### APPEAL SUMMARY

**Appeal ID:** 19041

**Project Address:** 631 SE Taylor St

**Building/Business Name:** The Rose Apartments

1  
GA3  
SECOND STORY LIFE SAFETY PLAN - APPEAL  
1/8" = 1'-0"

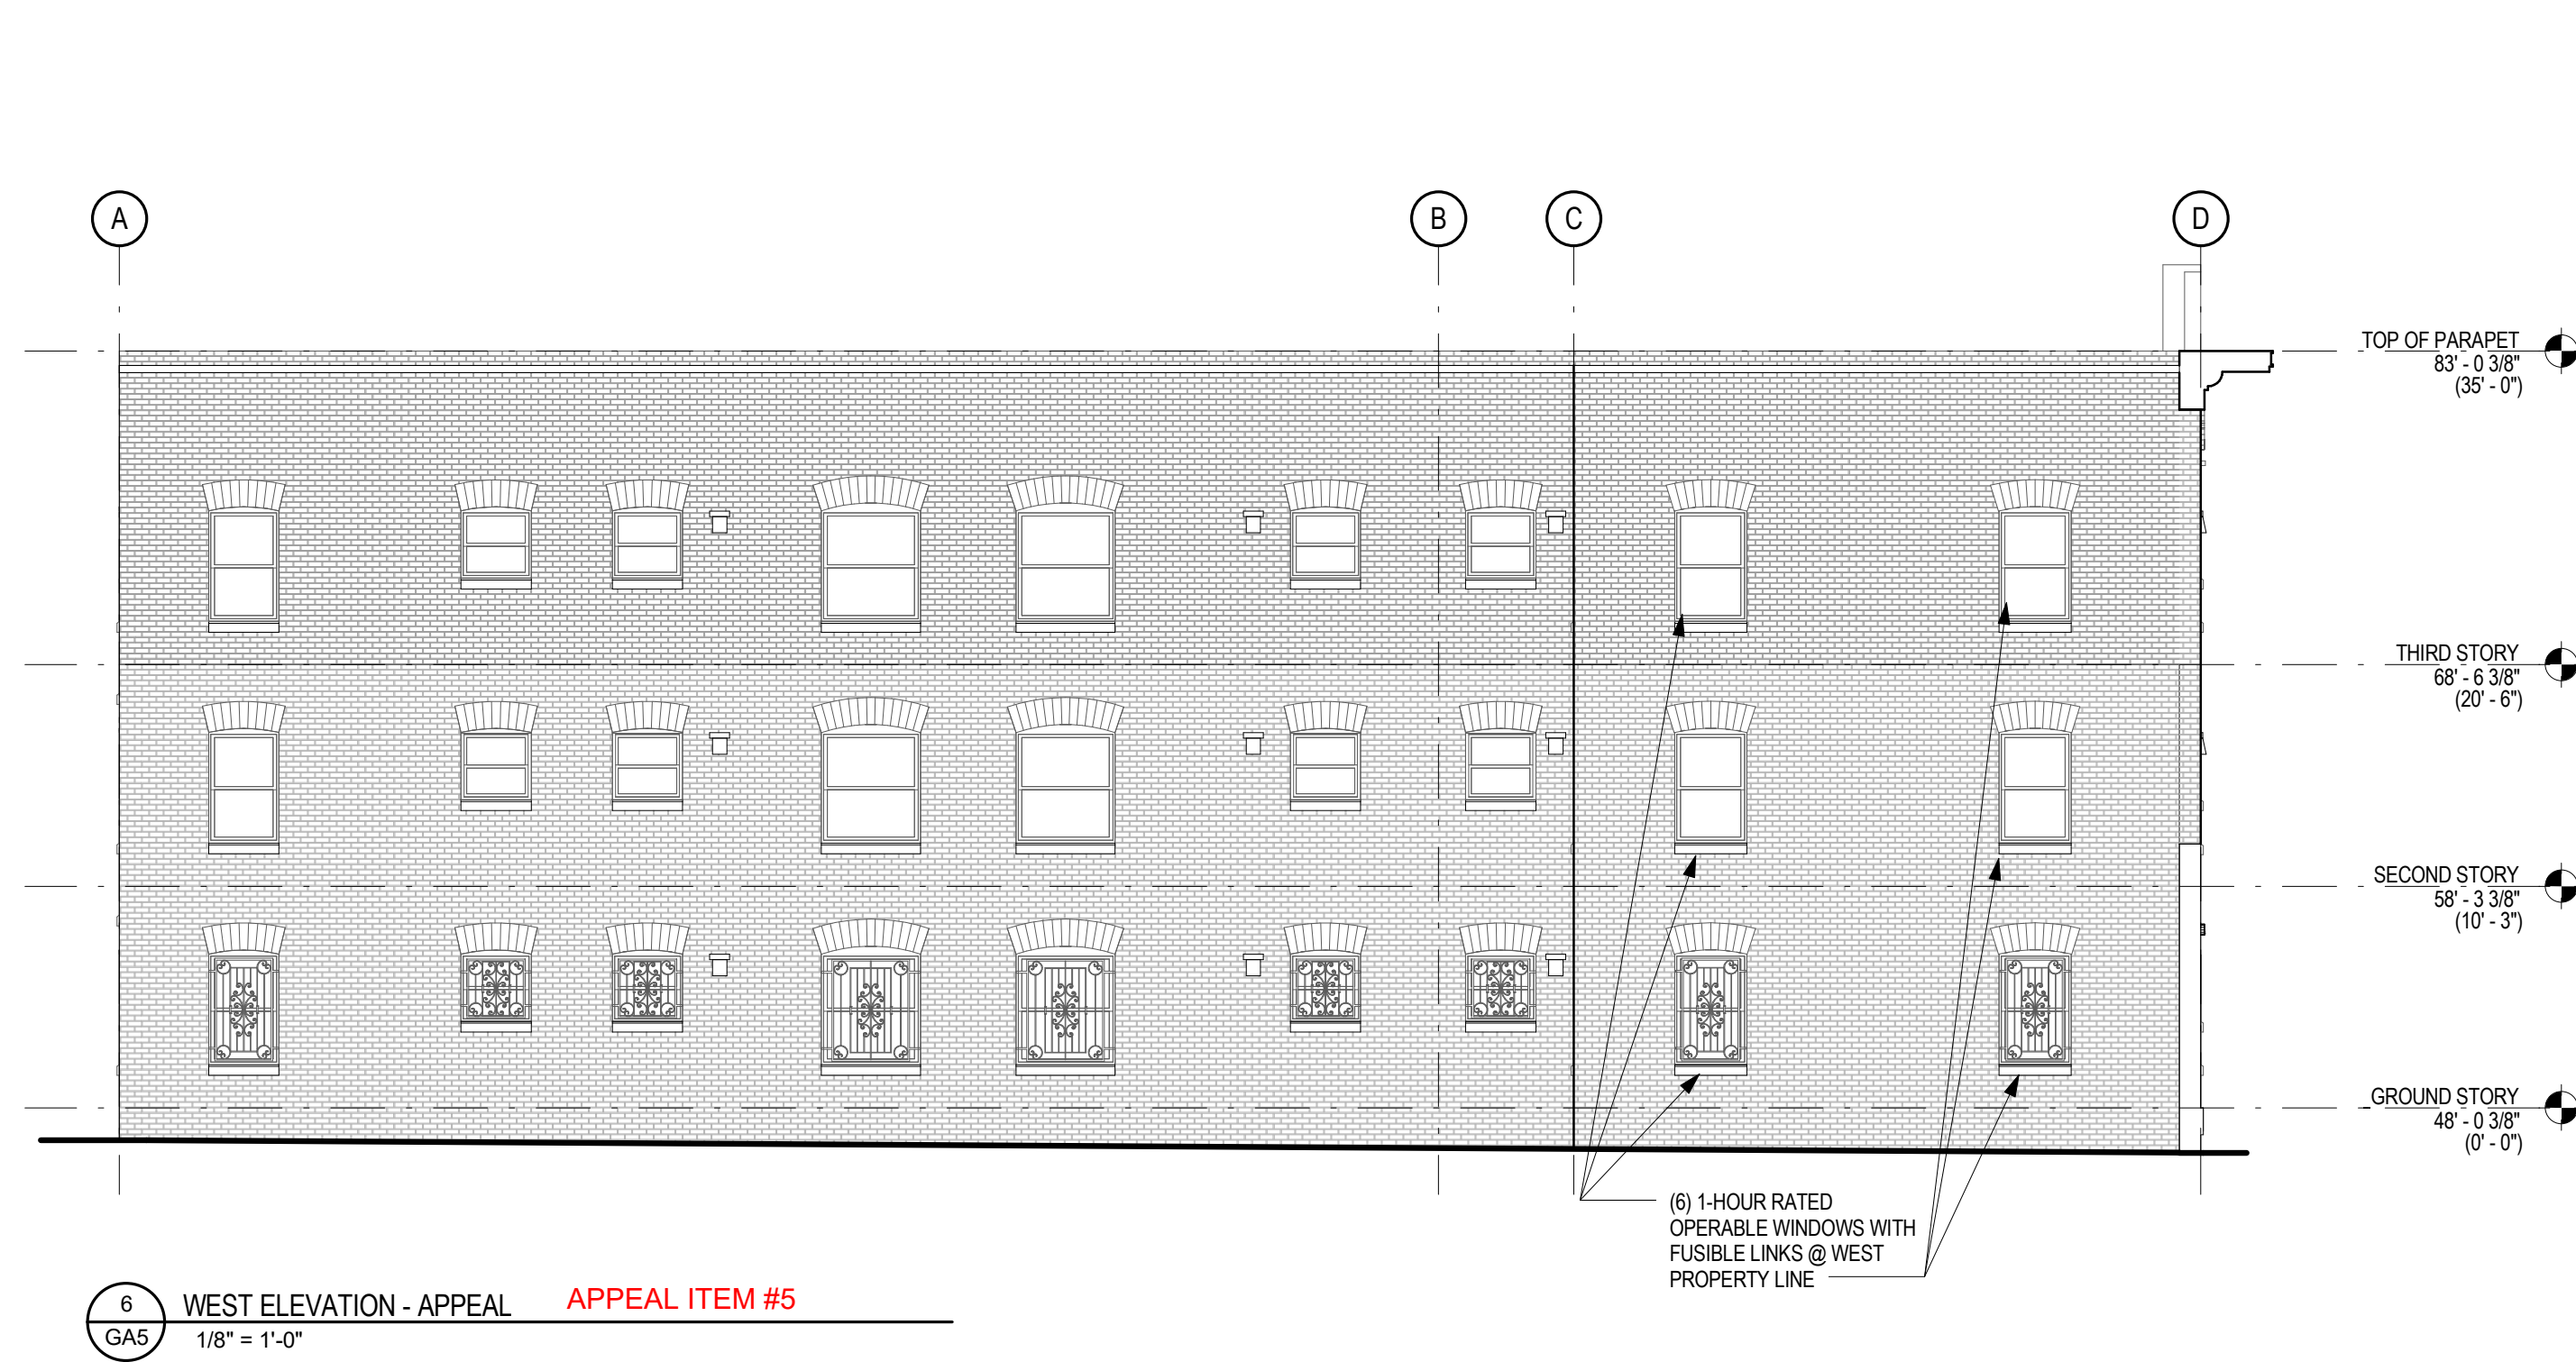
There is one existing ground story non-rated operable window along the western portion of the egress court (Unit 105). This window was approved by Appeal #6358. This window will be replaced with a UL listed ¾-hour fire-rated operable window with a fusible link that closes the window in the event of a fire. There are two existing ground story non-rated operable windows along the eastern portion of the egress court (Kitchen 124 and Food Pantry 123). These windows were approved by Appeal #6358. These windows will remain and be fixed in place, with additional sprinkler protection provided on the interior side. See Sheets GA2 and GA3.

<b>Code Section</b>	Table 705.8 Allowable Openings Based on Fire Separation Distance
<b>Requires</b>	Unprotected openings less than 3' from a property line are not permitted.
<b>Proposed Design</b>	<p>ORIGINAL APPEAL TEXT: The six unprotected operable windows at the west property line shall remain. The building shall be equipped with a full NFPA 13 sprinkler system throughout. See GA2 and GA3.</p> <p>RECONSIDERATION TEXT: The six unprotected operable windows at the west property line shall be replaced with UL listed 1-hour fire-rated operable windows with a fusible links that close the windows in the event of a fire. The building shall be equipped with a full NFPA 13 sprinkler system throughout. See GA2, GA3 and GA5.</p>

**1. Type 13 water curtain sprinkler protection at non-fire rated openings in exterior walls of egress court less than 10' in width: Granted provided windows are non-operable and sprinklers are spaced not more than 6 feet apart and placed a minimum of 6 inches and a maximum of 12 inches from the opening(s) and a maximum of 12 inches below the ceiling. Sprinklers are to be installed on the occupied side of the openings. A separate permit from the Fire Marshal's Office is required.**

**4. Unprotected windows at property line: Granted as proposed.**

6 WEST ELEVATION - APPEAL APPEAL ITEM #5  
GA5 1/8" = 1'-0"

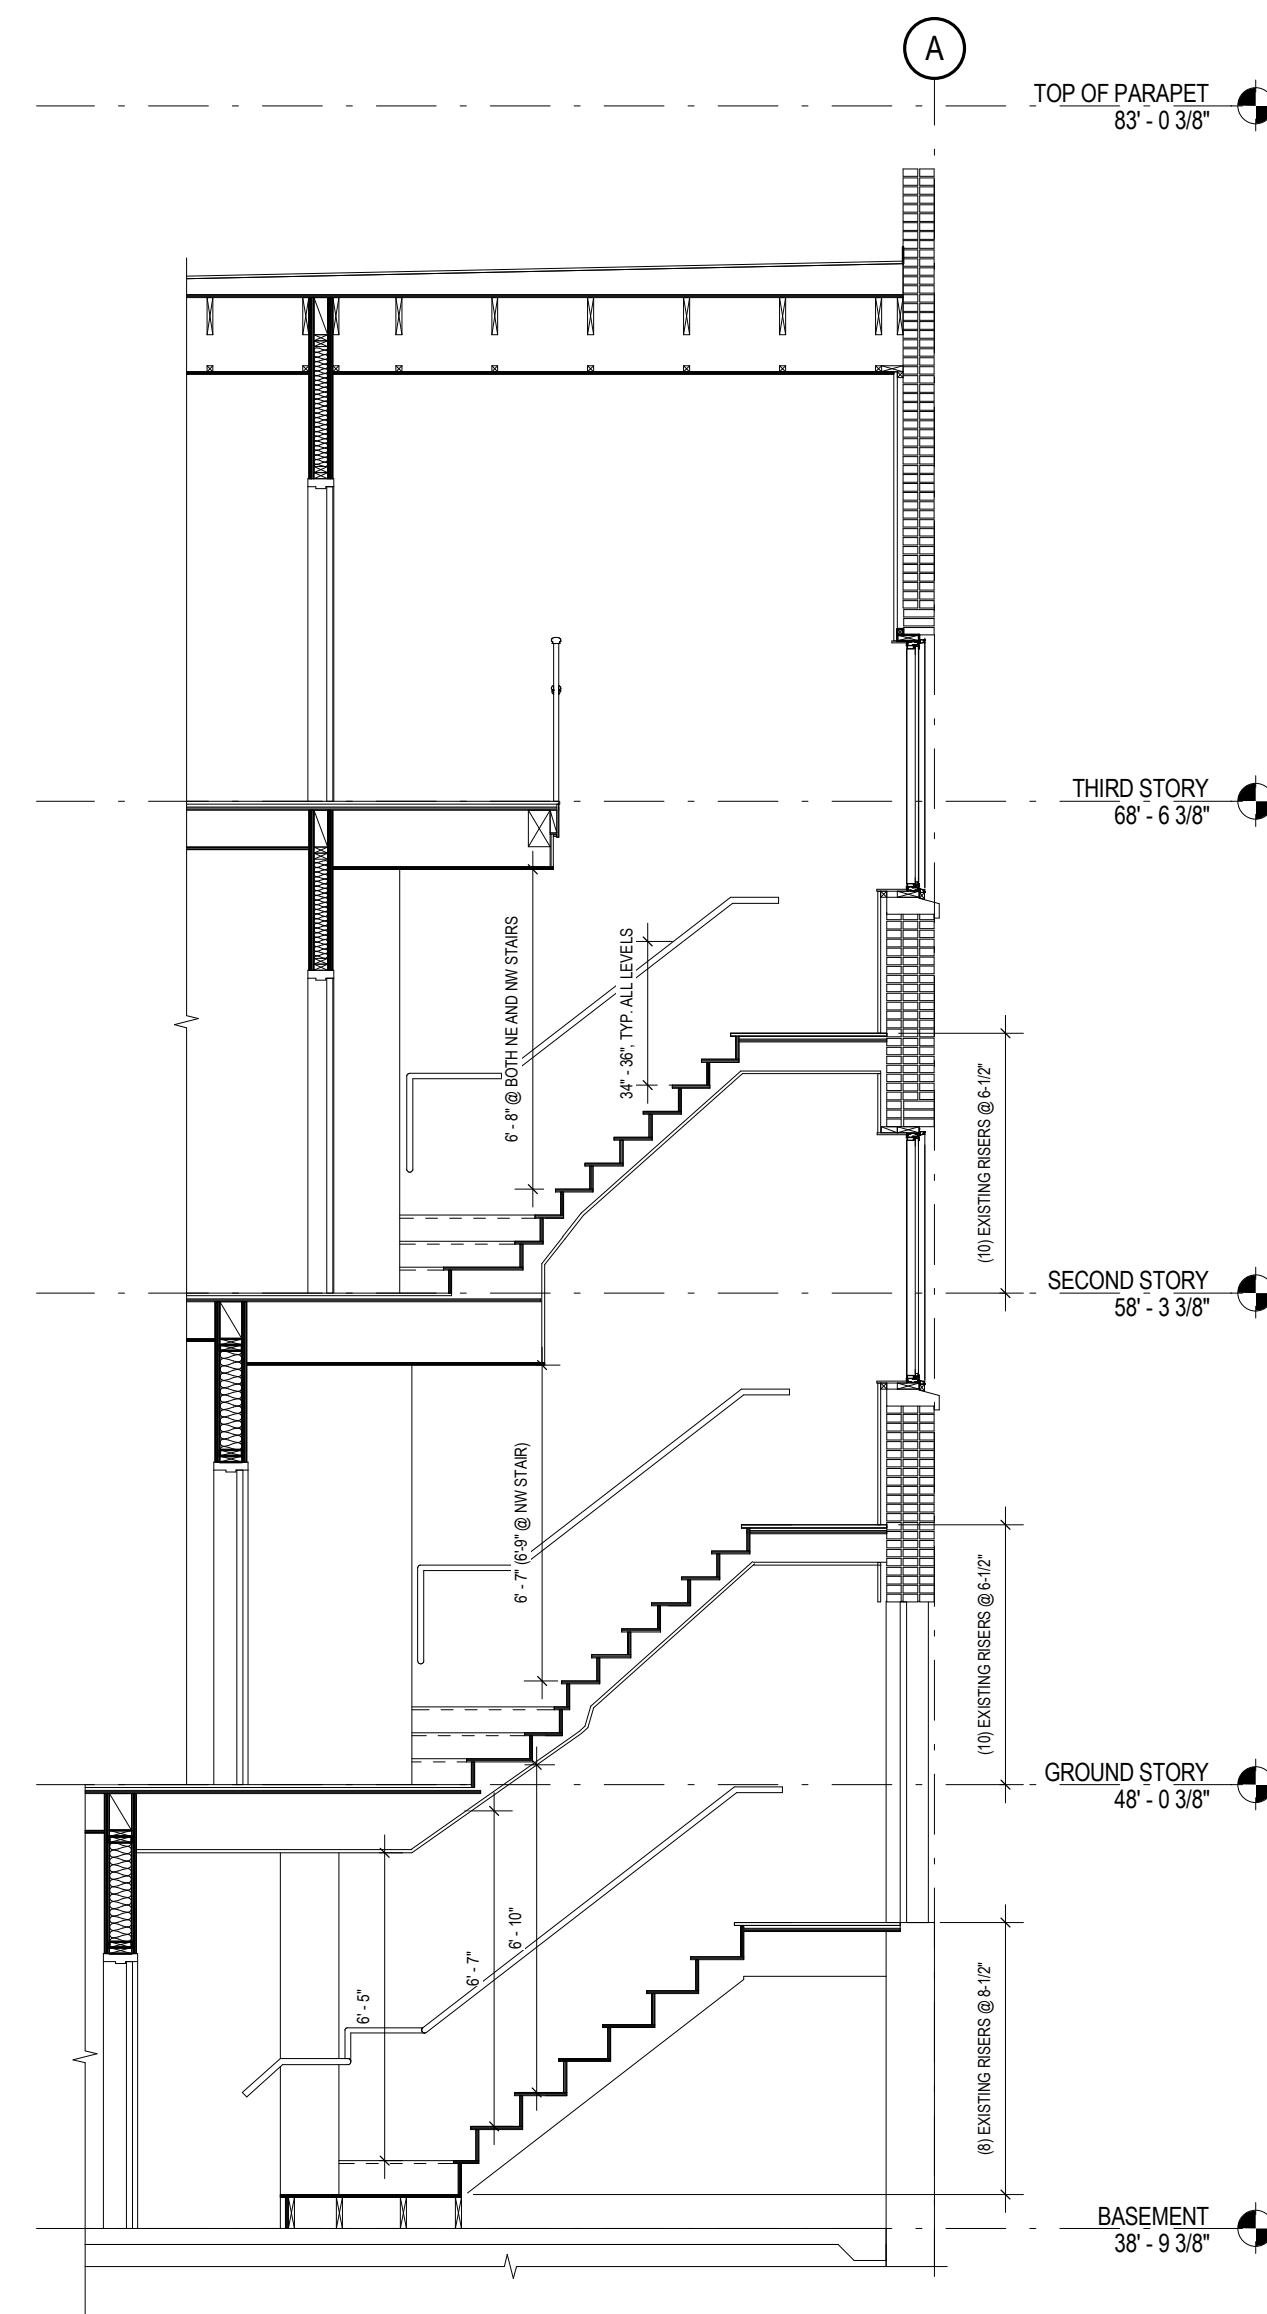
RECONSIDERATION TEXT: A portion of the west walls falls on the property line. There are six existing non-rated operable windows in this portion of the west wall. The windows were permitted in 2009 and allowed by Appeal #6358. The existing non-rated operable windows provide natural ventilation to the sleeping units, and the Owner does not wish to remove this feature. Per the Preliminary Life Safety Meetings, this appeal is only required because of the proposed removal of the building from the Chapter 13 program. The proposed UL listed 1-hour fire-rated operable windows that will automatically close in the event of a fire will mitigate the windows' location on the property line.
